DEVELOPMENT REVIEW COMMITTEE (DRC) COMMENT REPORT

PROJECT NAME: 11 Andrews

CASE NUMBER: UDP-S23038

REQUEST: Site Plan Level II Review: Amendment to Add 55 Multi-family Residential Units and Thirteen (13) Floors in the Downtown Regional Activity Center

F.2
DRC DESIGN
SUBMITTAL
19 June 2023

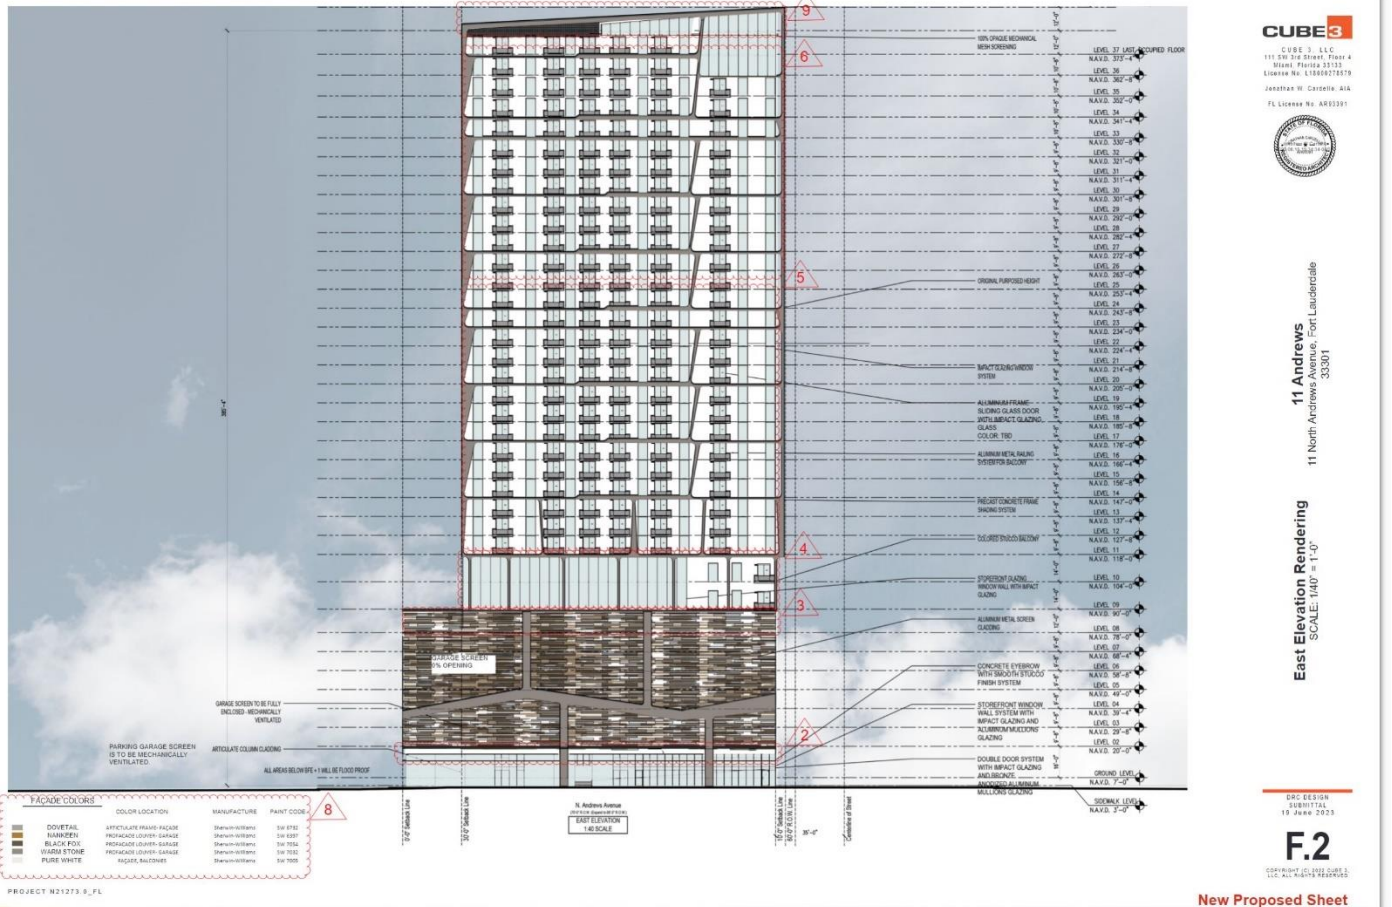
See (sheet F2, attached) show a floor plan of areas below base floor elevation + 1 to be floodproofed. Reference the sheet that you will show the floor elevations to be flood proofed. Show this on F3,F5

- Provide the finish floor elevation in feet using the NAVD 88 Datum and any flood levels below on Elevation (BFE 5' + 1' = 8' NAVD 88) The preliminary maps show a BFE of 6' NAVD 88 if these maps are in use at the time of your building permit you will need to meet the 6' + 1' = 7' NAVD 88

- Flood proofing is required for areas below BFE + 1' = FFE NAVD 88 (equipment and generator will need to meet BFE + 1' (Reference the floodproofing that will be done in these areas.)

- Show the elevation of the Elevator Pit (reference FEMA Technical bulletin 4) Technical Bulletin 4 provides guidance on the NFIP requirements for elevator machinery and equipment that serve buildings and provides guidance on the installation of elevators in special flood hazard areas. Elevator types and their associated equipment are described, along with practical methods to protect elevators and elevator shafts from flood damage.
